Afterburner - PCB upgrades

Document Ver. 1

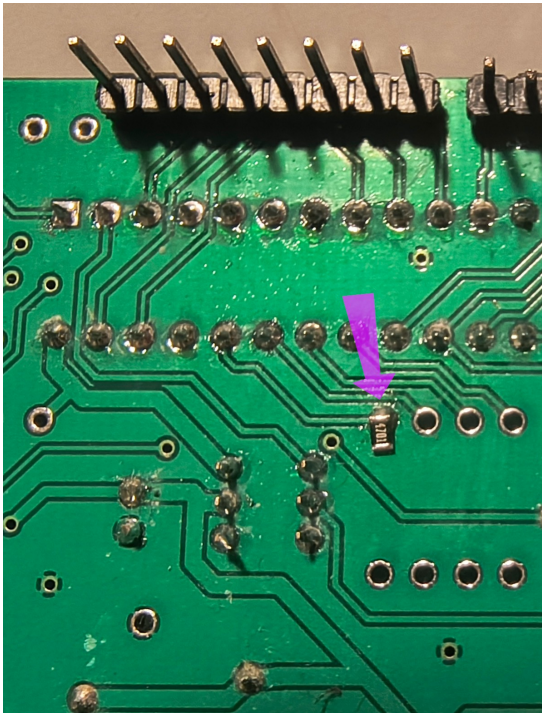
- desolder the right-most resistor of the R1 group (next to the switch)

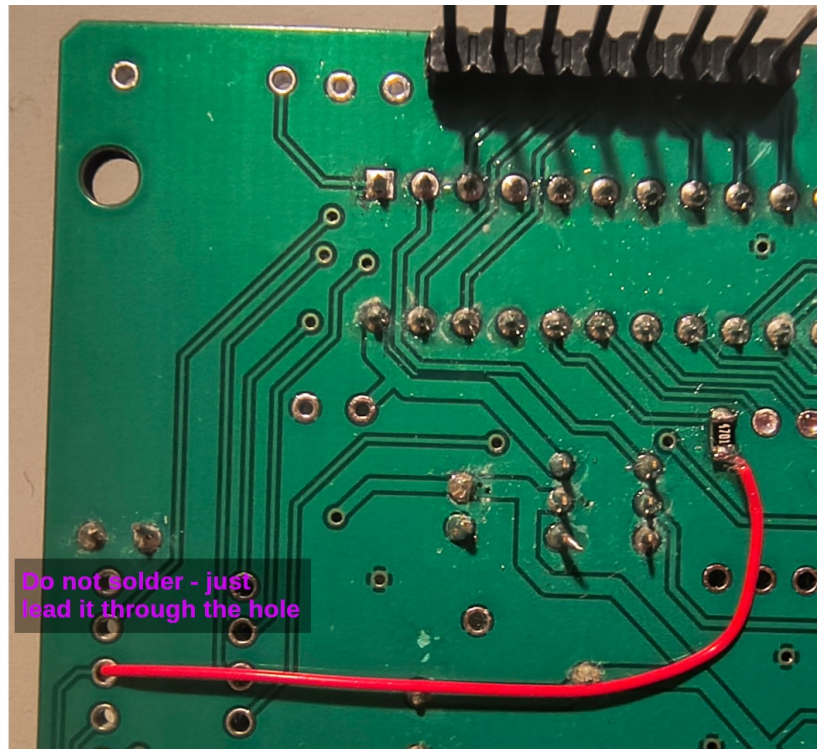
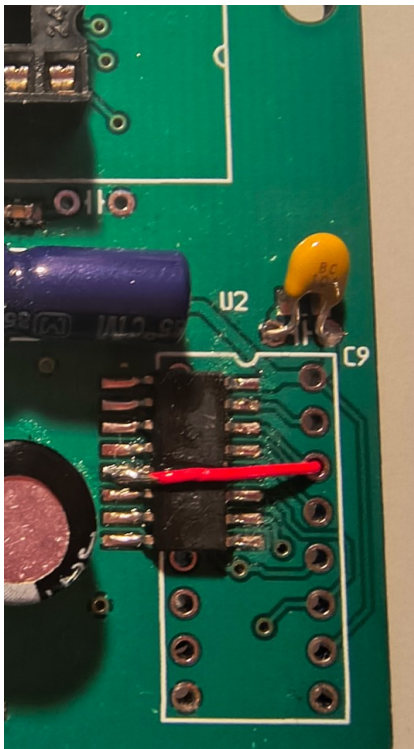
- solder the desoldered resistor on the bottom side of the PCB

- connect a thin **insulated** wire from the resistor to pin 5 of U2 (shift register 74HC595)

4) PCB 3.1 to PCB 3.2 mod

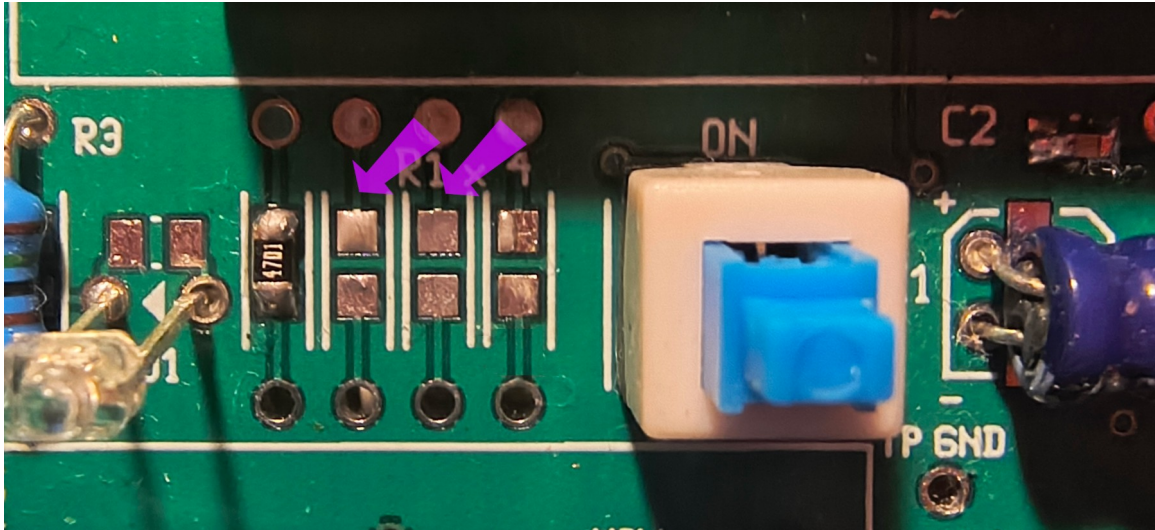
- desolder the middle 2 resistors of the R1 group (on PCB 3.1 keep the 1st and the 4th resistor soldered)

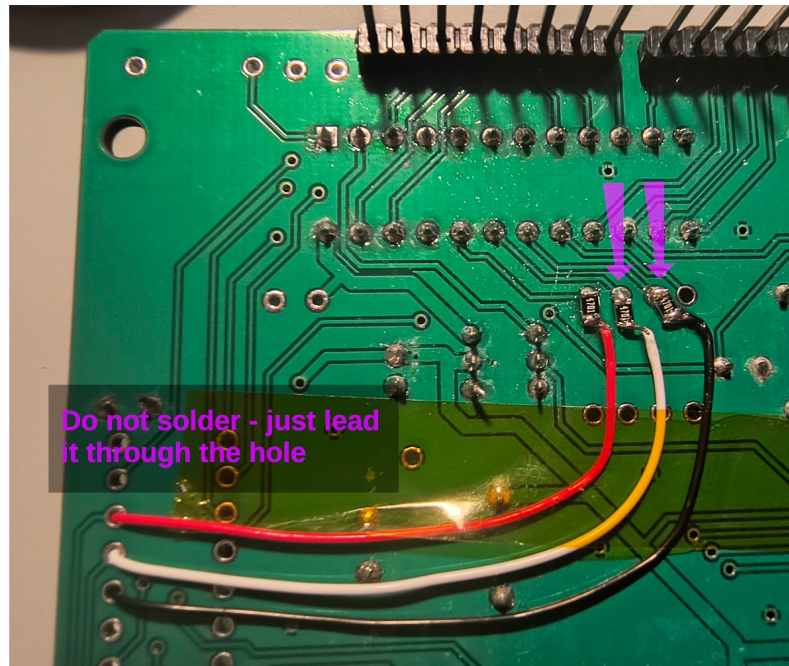
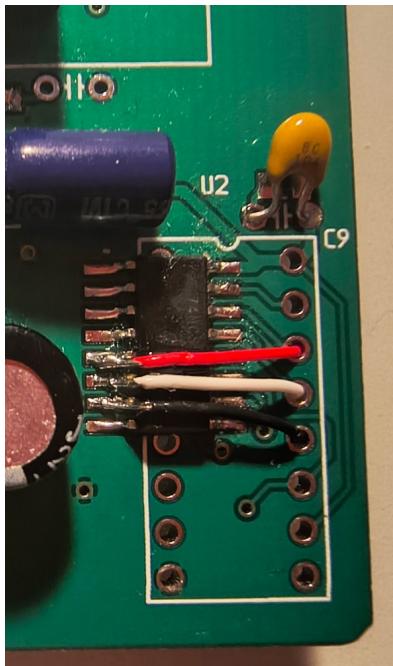
- solder the desoldered resistors on the bottom side of the PCB
- connect a thin **insulated** wire from each resistor to its appropriate pin (6 and 7) of U2 (shift register 74HC595).
